SERVICE BULLETIN

NON-MODIFICATION SERVICE BULLETIN — ENGINE — PACKING —
REMOVAL OF SUSPECT PACKINGS

V2500 Series 72-0705

V2500-ENG-72-0705

LOCATION OF TUBE 181
FIGURE 1

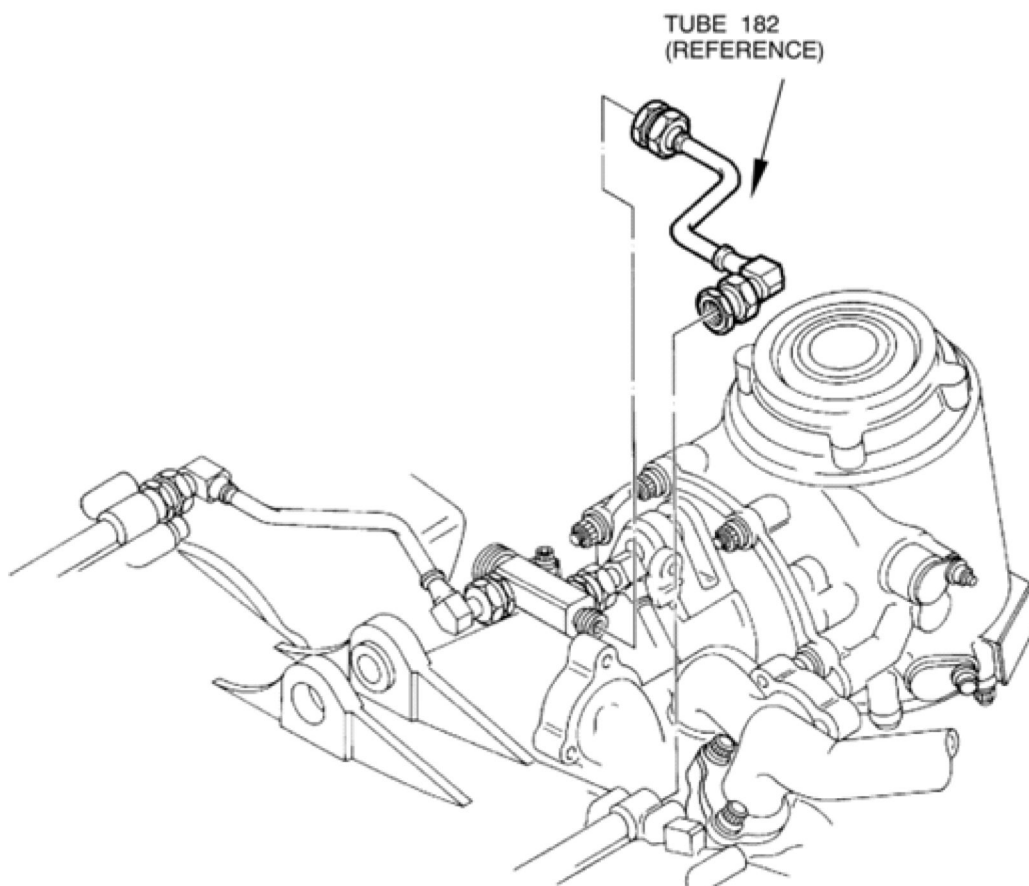
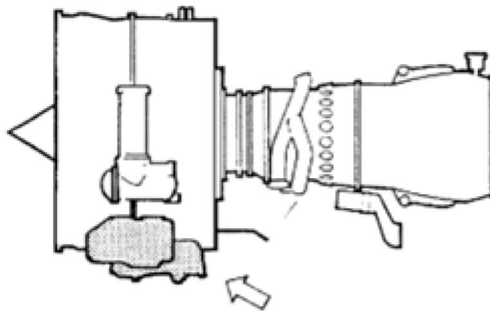
- A. Disconnect the Tube 181 at the Angle Gearbox and at the distributor, and remove Tube 181. See Figure 1 and Figure 4.

- F. Install Tube 181, between AGB and distributor. Torque both ends to 204 to 221 lbf-in (23 to 25 N.m). Safety with V02-126 lockwire. See Figure 1 and Figure 4.

LOCATION OF TUBE 182
FIGURE 2

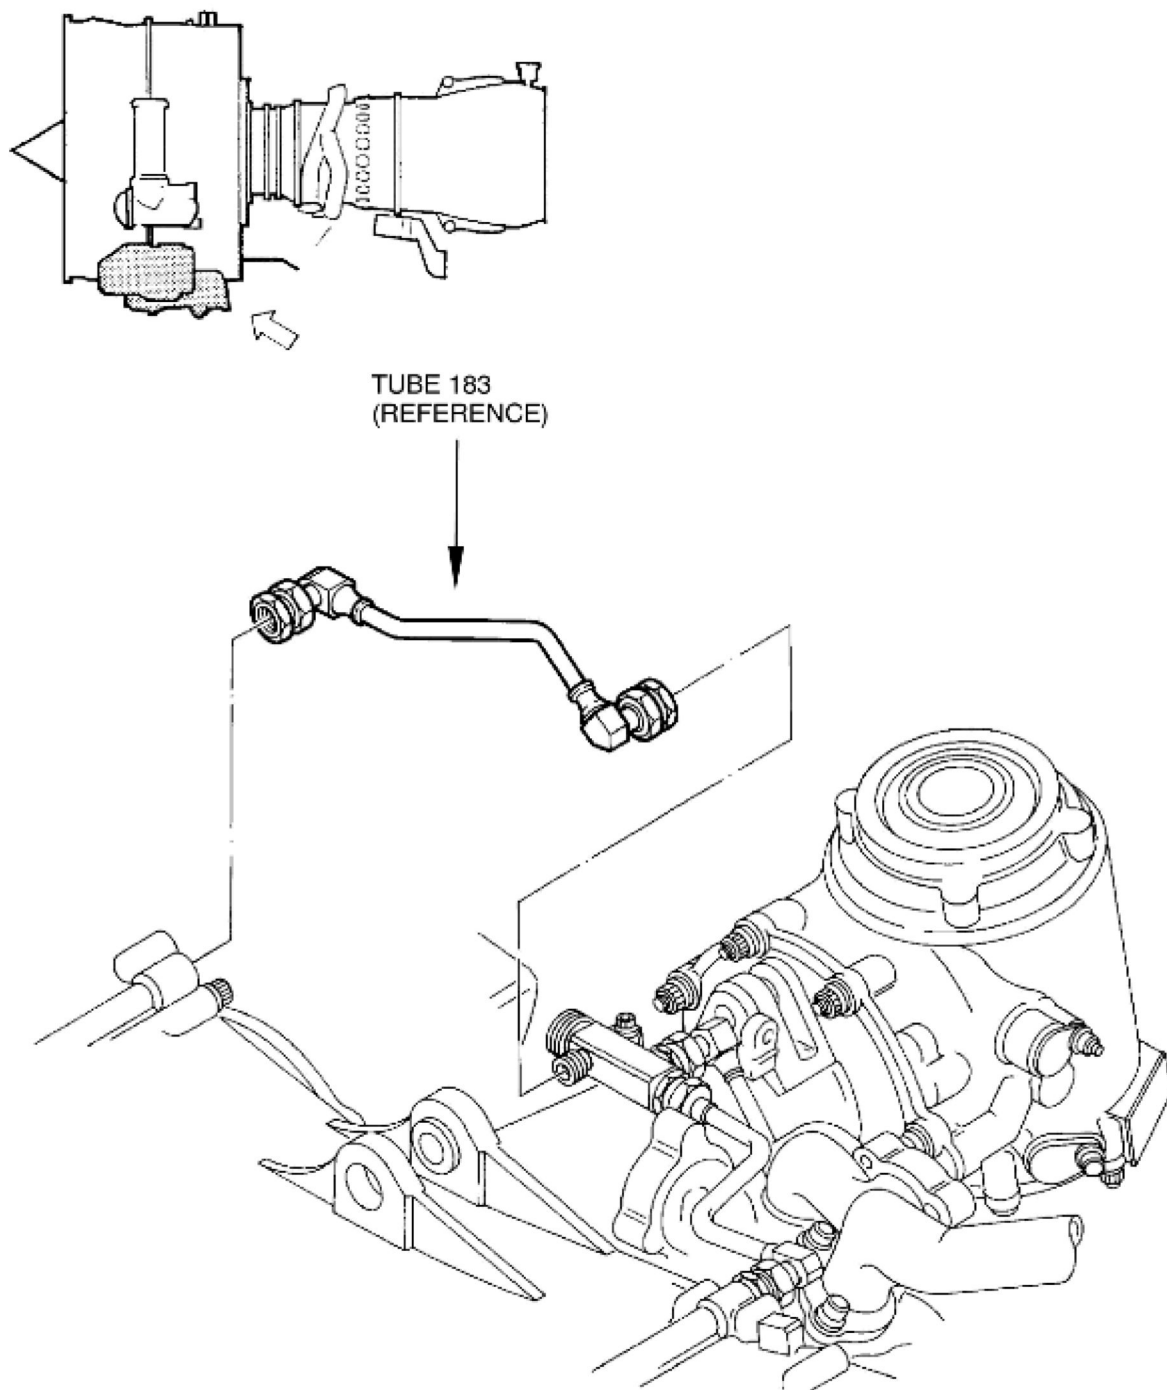
- B. Disconnect the Tube 182 at the gearbox and at the distributor, and remove Tube 182. See Figure 2 and Figure 4.

- F. Install the two bolts and torque to 85 to 95 lbf-in (9.6 to 10.7 N.m).
 - G. Install the Tube 182 on the gearbox between the distributor and the gearbox, adjacent to the scavenge pump. Torque the both ends of the tube to 204 to 221 lbf-in (23 to 25 N.m). Safety with V02-126 Lockwire. See Figure 2 and Figure 4.

LOCATION OF TUBE 183
FIGURE 3

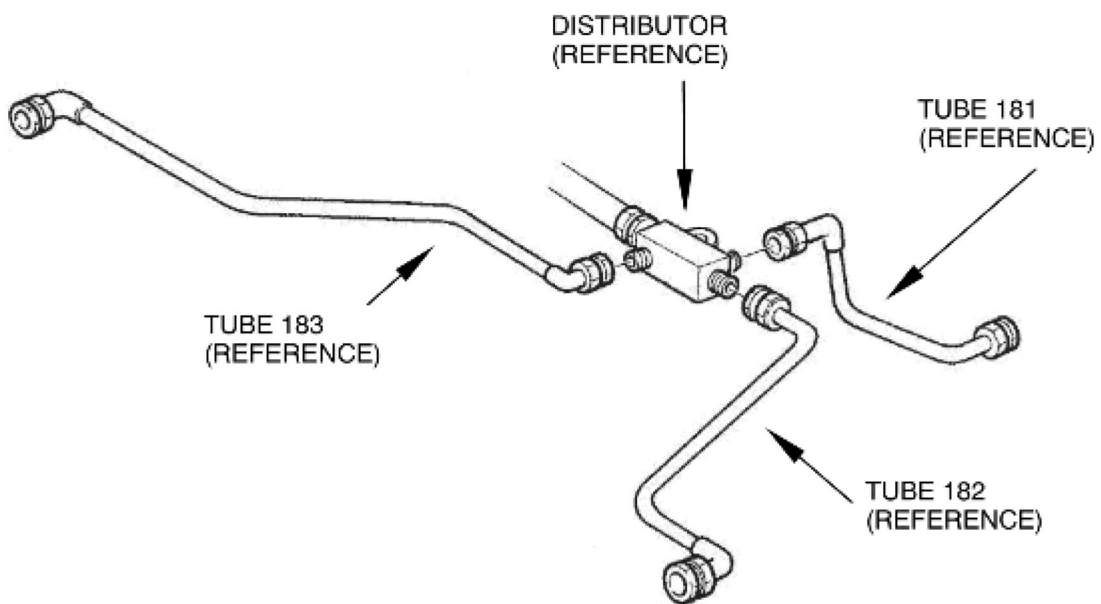
- A. Disconnect the Tube 183 at the gearbox and at the distributor, and remove the Tube 183. See Figure 3 and Figure 4.
NOTE: With an applicable tool, hold the distributor to prevent movement and remove the Tube 183.

- E. Install the two bolts and torque to 85 to 95 lbf-in (9.6 to 10.7 N.m).
 - F. Install the Tube 183 on the gearbox between the distributor and the gearbox, adjacent to the Integrated Drive Generator (IDG). Torque the both ends of the tube to 204 to 221 lbf-in (23 to 25 N.m). Safety with V02-126 Lockwire. See Figure 3 and Figure 4.

LOCATION OF PACKING (TUBE 181 LOCATION)
FIGURE 5

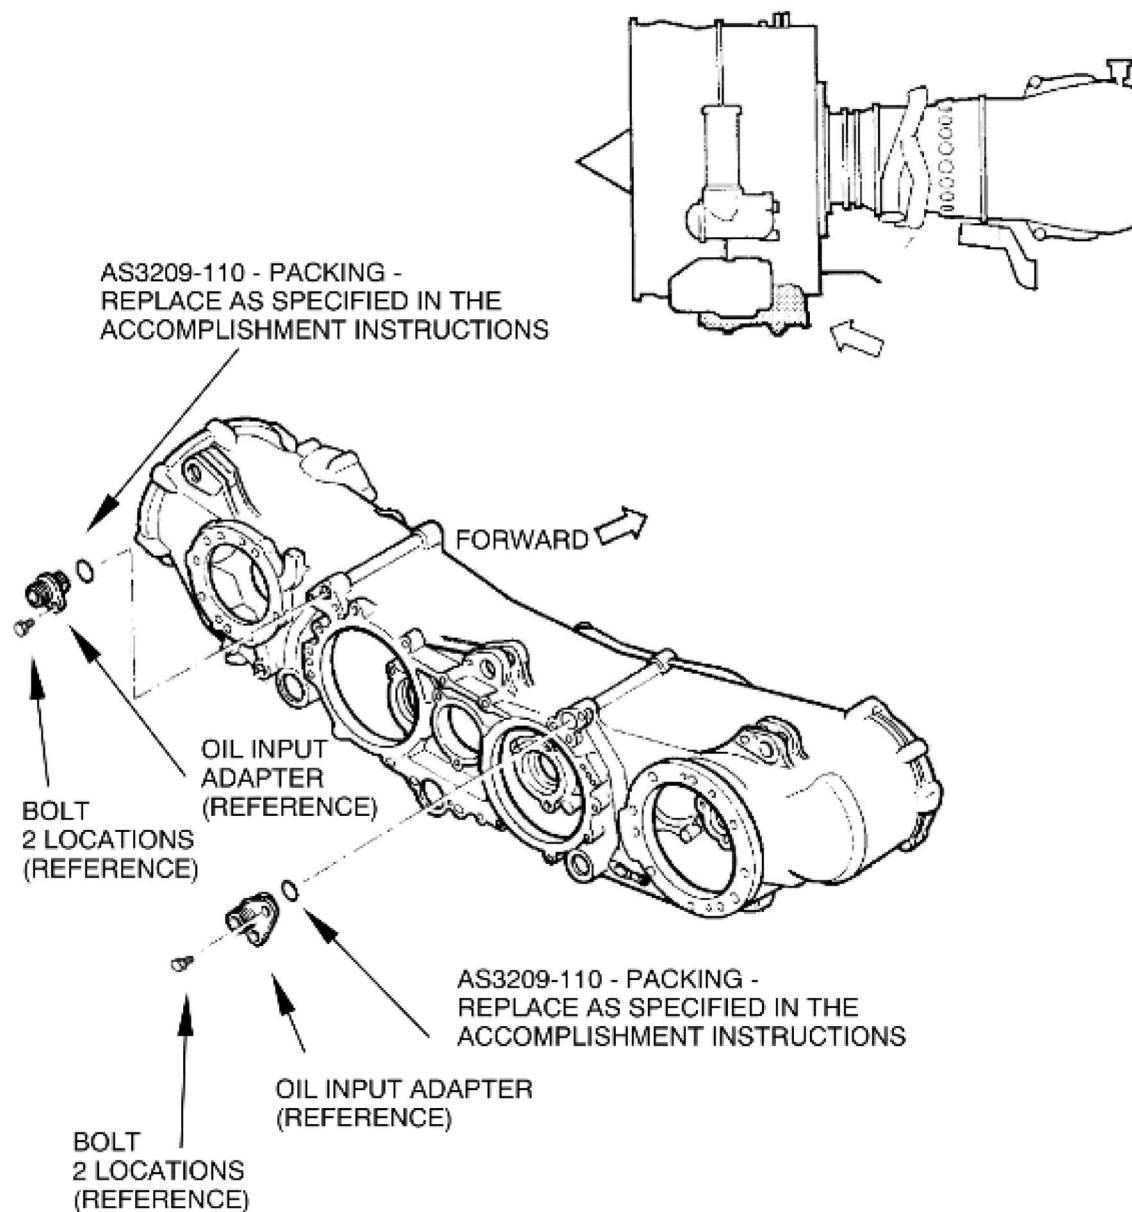
- B. Remove oil input adapter (item 01-200) from the front of the Angle Gearbox Casing. See Figure 5.

- C. Install new Packing, PN AS3209-110 (item 01-220) into the groove of oil input adapter. See Figure 5.

- E. Install the two bolts and torque to 85 to 95 lbf-in (9.6 to 10.7 N.m).

- 1. Replace Packing, PN AS3209-110 with new at the angle gearbox near Tube 181 as specified in Reference 3, EM Task 72-60-40-040-001 and Task 72-60-40-440-001. See Figure 5.
- 2. Replace Packing, PN AS3209-110 with new at gearbox left side near Tube 182 as specified in Reference 3, EM Task 72-60-21-040-001 and Task 72-60-21-440-001. See Figure 6.
- 3. Replace Packing, PN AS3209-110 with new at gearbox right side near Tube 183 as specified Reference 3, EM Task 72-60-21-040-001 and Task 72-60-21-440-001. See Figure 6.
